MEMORANDUM

RE: Special Exception to allow access from Skyline Drive to serve Lot 2, Block 13 located in Section 2, T1N, R7E, BHM, Rapid City, South Dakota

No. 04PL042 - Layout Plat

Re: Driveway Access – Lot 2, Smith Subdivision

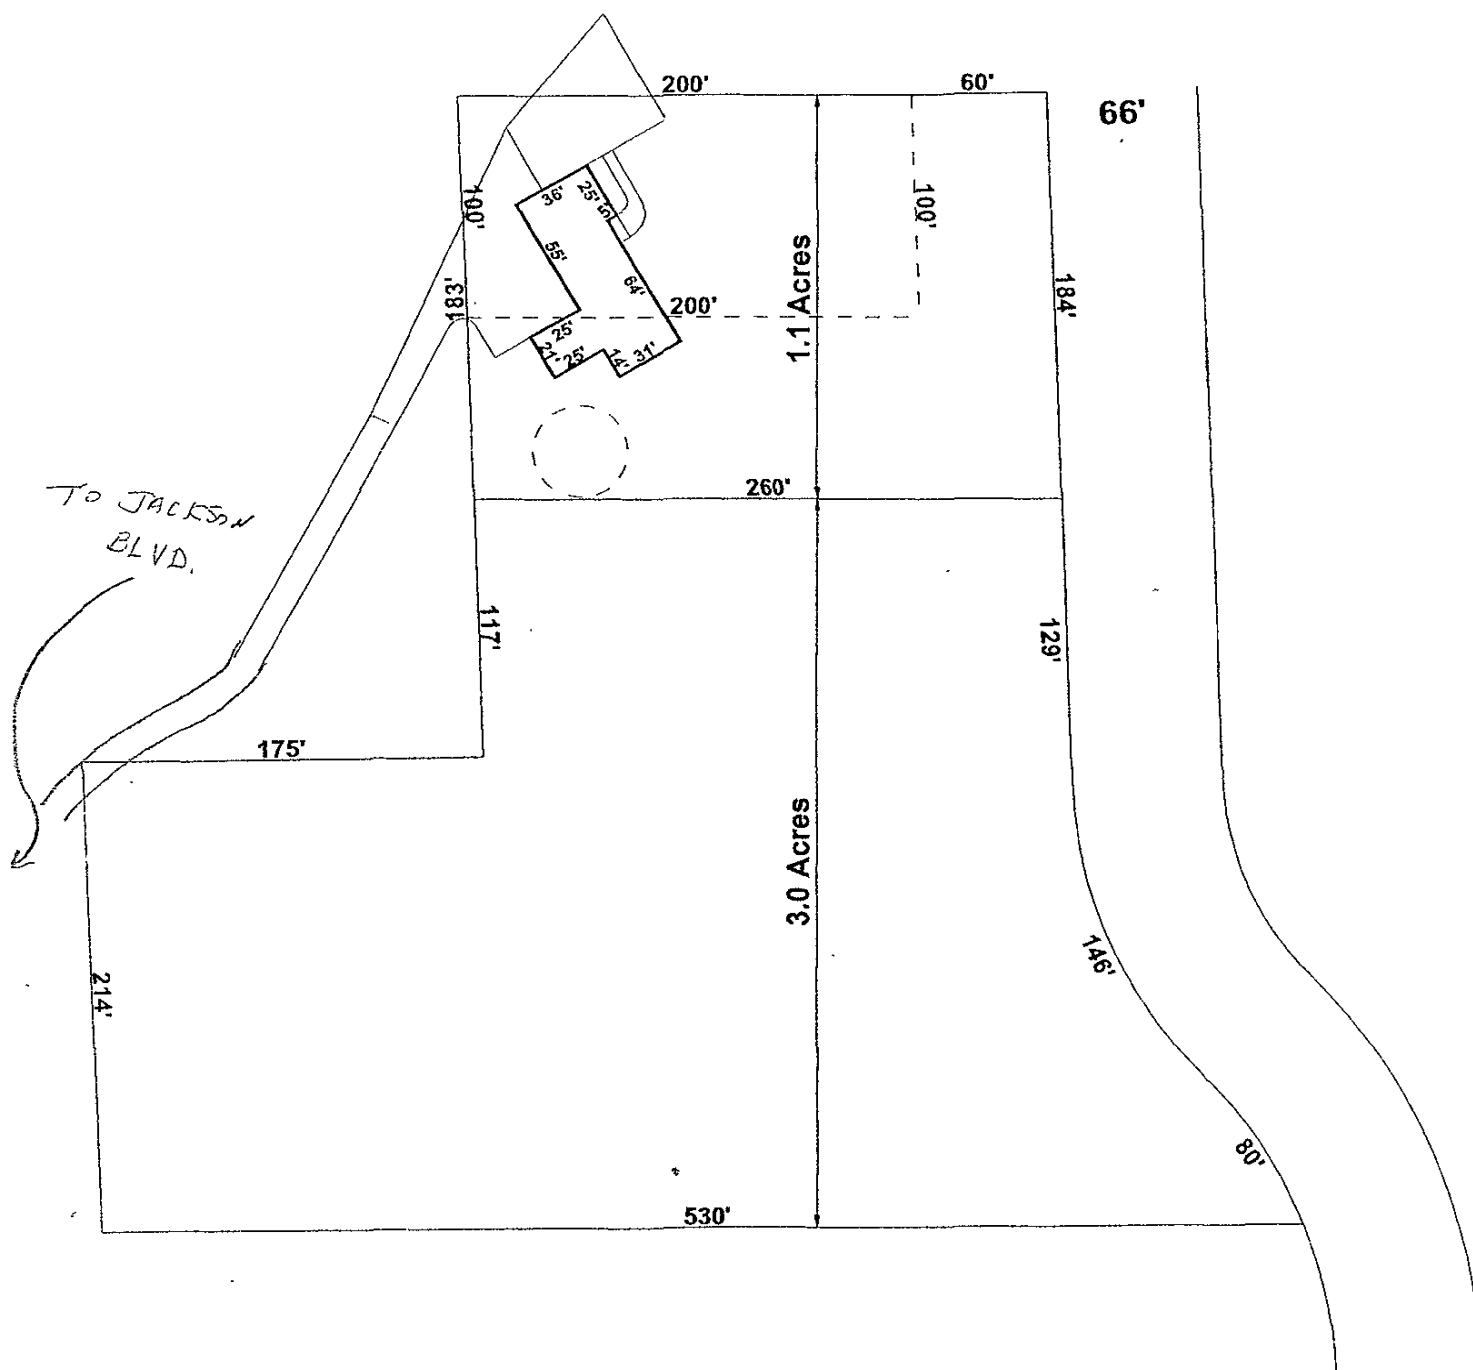
Lot Size: The property is zoned Park Forest District requiring a minimum three acre lot size. Currently, the lots are sized .46 acres and 3.7 acres, respectively. The proposed Layout Plat identifies that the reconfigured lots will be sized 1.1 acres and 3 acres respectively. As such, prior to submittal of a Final Plat, a Variance to Zoning Ordinance to reduce the minimum required lot size in the Park Forest District from three acres to 1.1 acres must be obtained.

Access Easement: Currently, an access easement extending north from Valentine Street serves as legal access to the subject property. The access easement is classified as a lane place street requiring that it be located in a minimum 49 foot wide right-of-way and constructed with a minimum 24 foot wide paved surface, curb, gutter, sidewalk, street light conduit, sewer and water. Currently, the street is located in a 40 foot wide easement and constructed with an approximate 20 foot wide graveled road. Upon submittal of a Preliminary Plat, road construction plans shall be submitted for review and approval as identified for that portion of the access easement located on the subject property or a Variance to the Subdivision Regulations must be obtained.

Skyline Drive: Skyline Drive is located along the east lot line and is classified as a collector street on the City's Major Street Plan requiring that the street be located in a minimum 76 foot wide right-of-way and constructed with a minimum 40 foot wide paved surface, curb, gutter, sidewalk, street light conduit, water and sewer. Currently, Skyline Drive is located in a 66 foot wide right-of-way and constructed with an approximate 24 foot wide paved surface. As such, staff is recommending that upon submittal of a Preliminary Plat, road construction plans be submitted for review and approval. In addition, the plat document must be revised to show the dedication of five additional feet of right-of-way along Skyline Drive or a Variance to the Subdivision Regulations shall be obtained.

Staff recommends that the Layout Plat be approved with the following stipulations:

FIGURE 2
ALTERNATIVE A
ACCESS DRIVEWAY FOR LOT 2

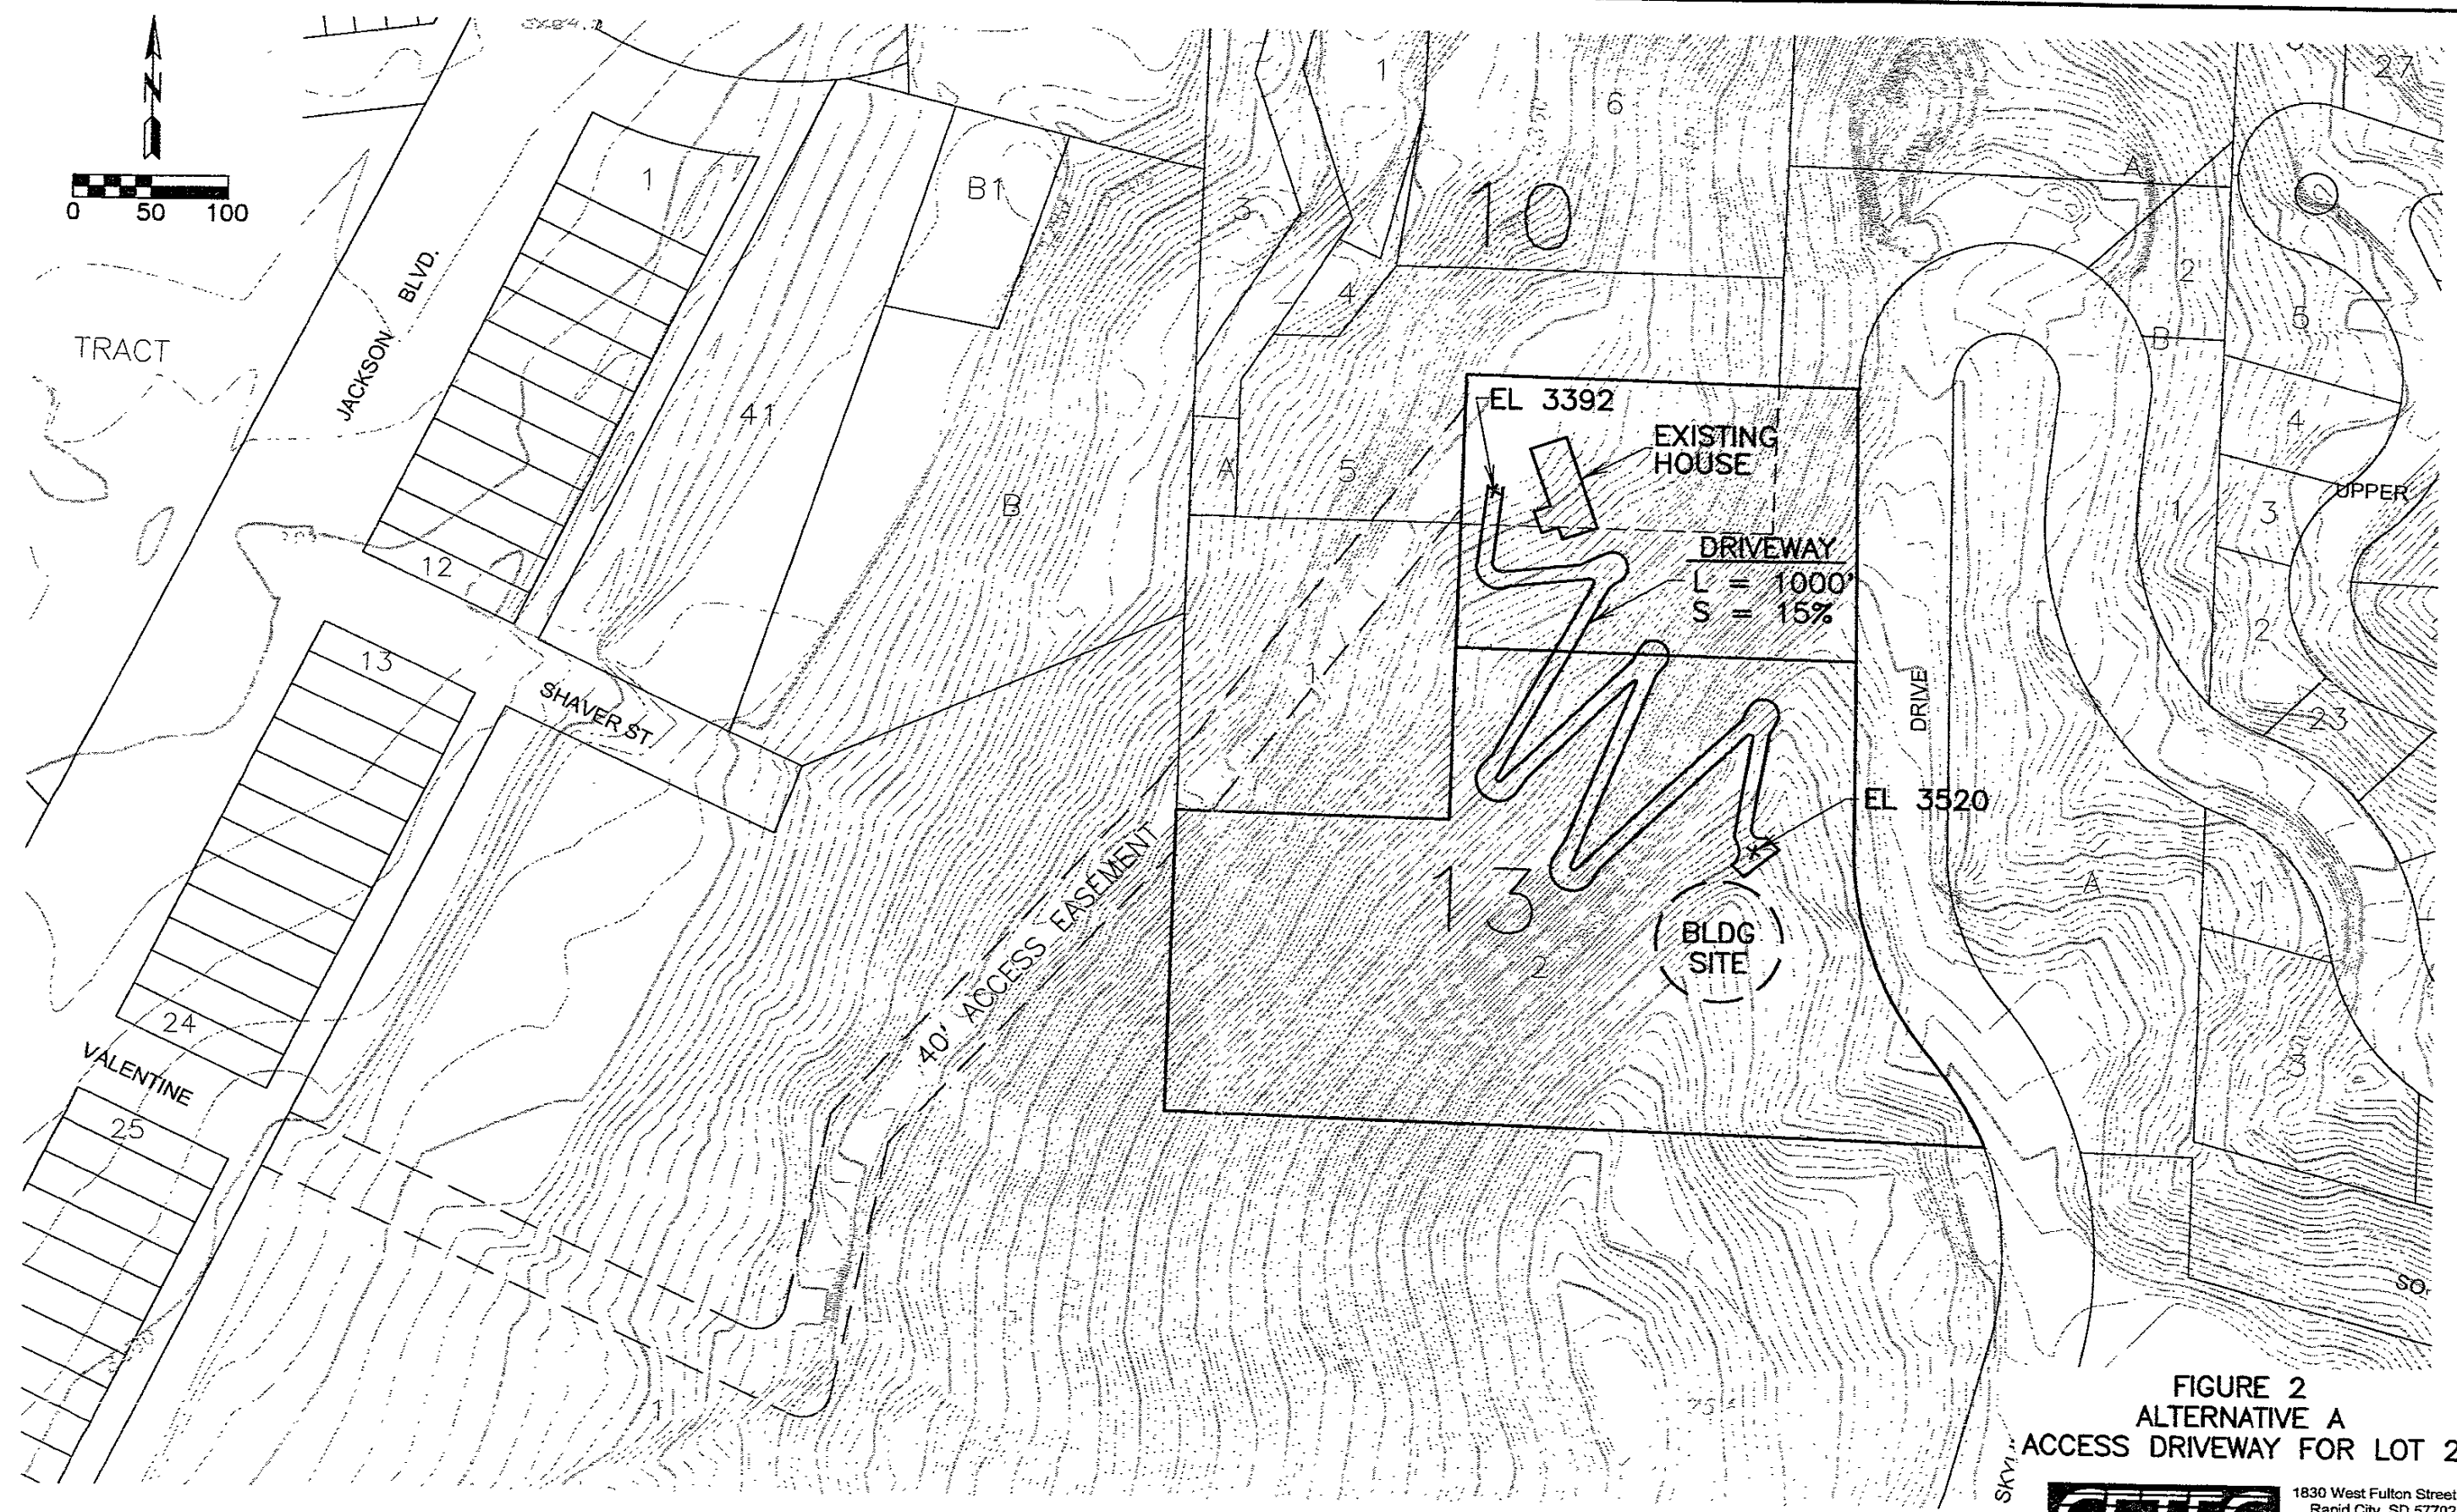
The applicant's Engineer has submitted a letter summarizing his findings and engineering opinions regarding the construction of a driveway from the easement verses Skyline Drive. Staff concurs that the 15% driveway gradient from the easement is more than the 12% driveway gradient from Skyline Drive; however, the Rapid City Municipal Code states that a driveway may be up to 16% gradient. As such, the driveway from the access easement meets City standards and preserves the integrity of Skyline Drive as a scenic roadway as well as precludes any additional traffic on a sub-standard collector street.

Alternative A is illustrated conceptually on Figure 2 attached to this report. The driveway alignment commences on proposed Lot 1 at the existing driveway to your home, and traverses up the steep westerly slope of the lot using a series of switchback curves. The overall driveway length is approximately 1,000' with a gradient averaging about 15%. This alternative would require an easement from your proposed Lot 1. Construction of this type of driveway would essentially destroy the hillside and would create severe

problems with slope stability, erosion and safety, among others. It is my opinion that this option is technically **not feasible** and is **not recommended**.

FIGURE 3
ALTERNATIVE B
ACCESS DRIVEWAY FOR LOT 2

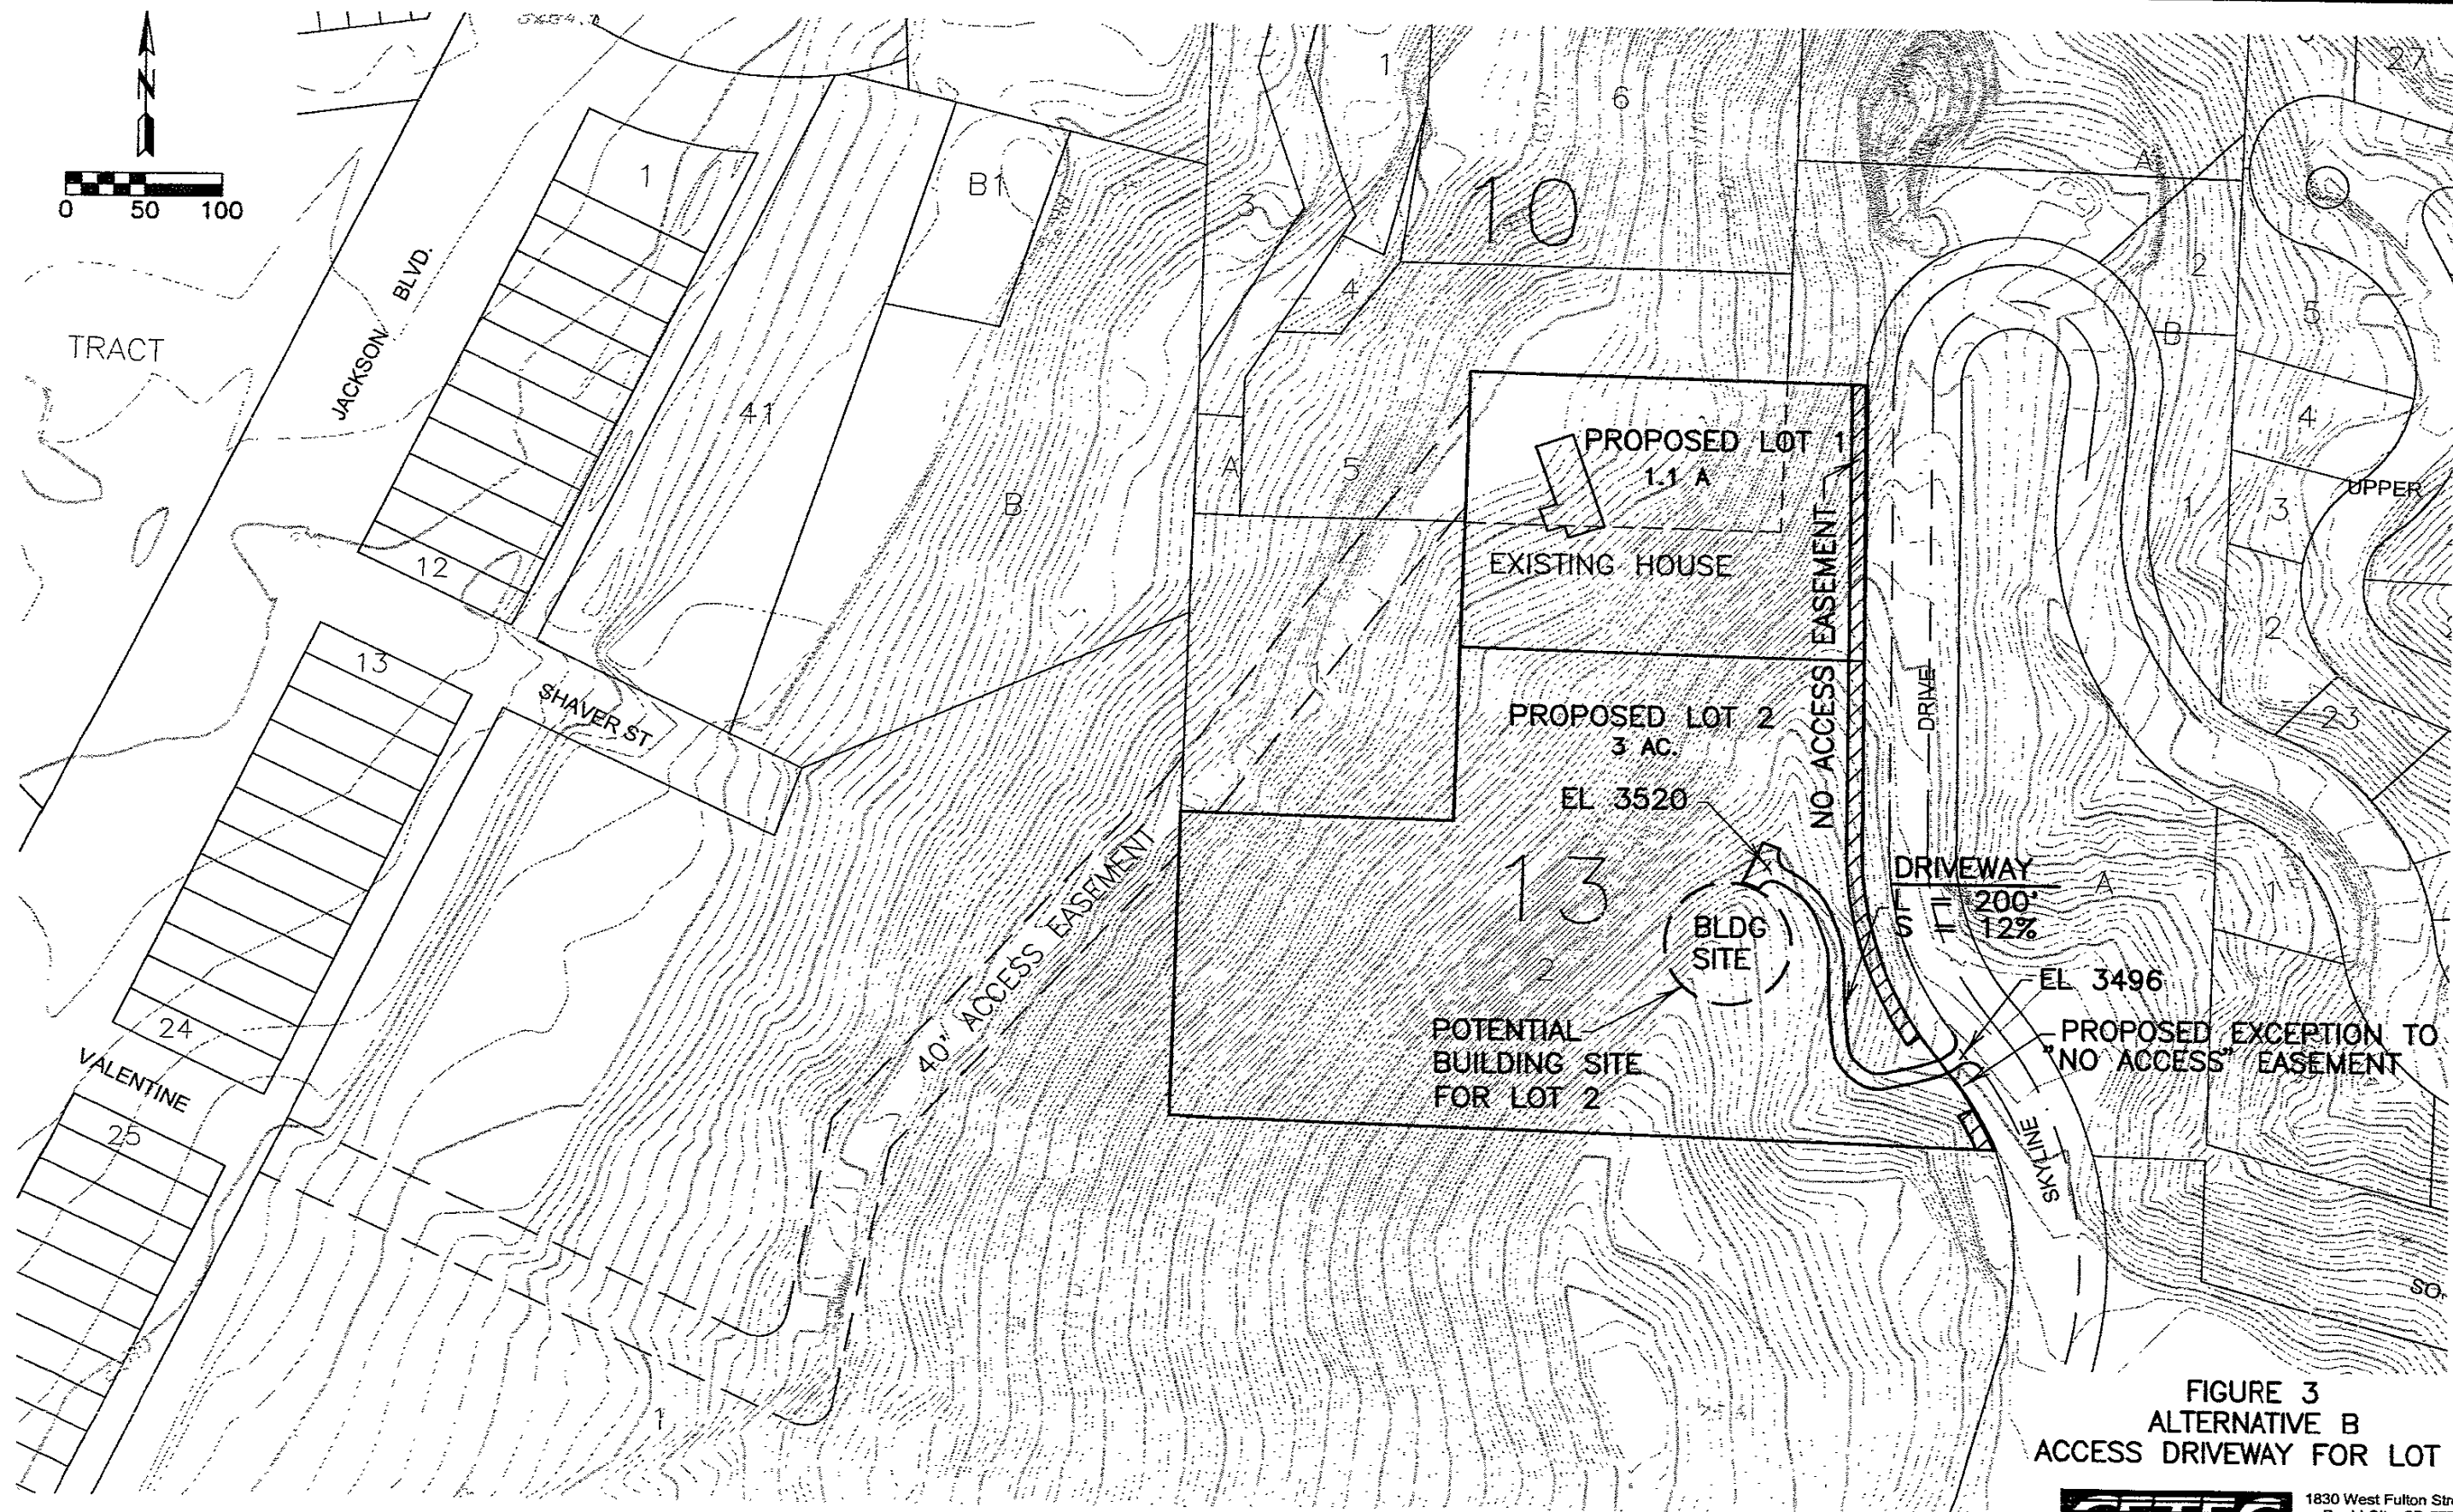
Alternative B is illustrated conceptually on Figure 3 attached hereto. This option results in a driveway length of about 200' at an average gradient of about 12%. The connection to Skyline is at a natural swale in the terrain which provides for satisfactory sight distances for Skyline traffic. A moderate amount of grading and surface disturbance will be required. This option appears to be technically feasible and is the **recommended alternative** for access to the building site.

In summary, it is my opinion that access to the buildable portion of proposed Lot 2 is feasible only from Skyline Drive. The recommended location for the approach to Skyline is approximately 60' north of the southeast corner of Lot 2 as illustrated on Figure 3.

Recommendation: Staff is recommending that the Special Exception to allow access from Skyline Drive which is not the lesser order street be denied.
